Staff Report & Recommendation

Historic Preservation Board

SUBJECT: HPB17-0096, **809 2nd Street.**

The applicant has submitted plans entitled “New Townhomes for 809 2nd Street” as prepared by SKLARchitecture, dated April 24, 2017.

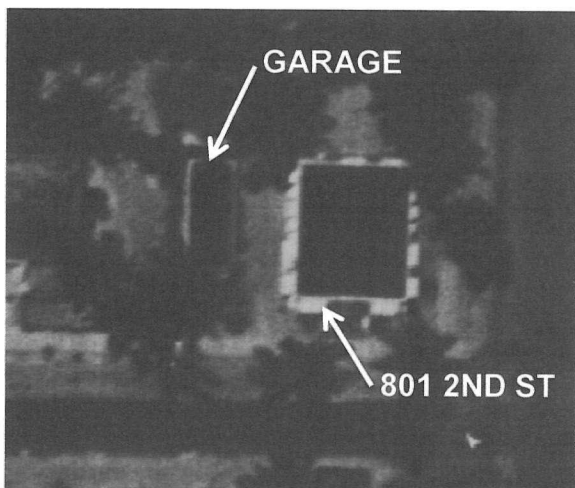
The existing structure was originally constructed in 1930 as a 1-story garage for the residence immediately adjacent to the east (801 2nd Street). In 1951, a 1-story attached addition was constructed to the south and east of the garage, resulting in a 3-unit multifamily building.

Considering the fact that the original garage structure has been subsumed into the 1951 addition and that the design of the addition is unremarkable with no significant architectural elements, staff, in this instance, has no objection to the applicant's request for the total demolition of the building.
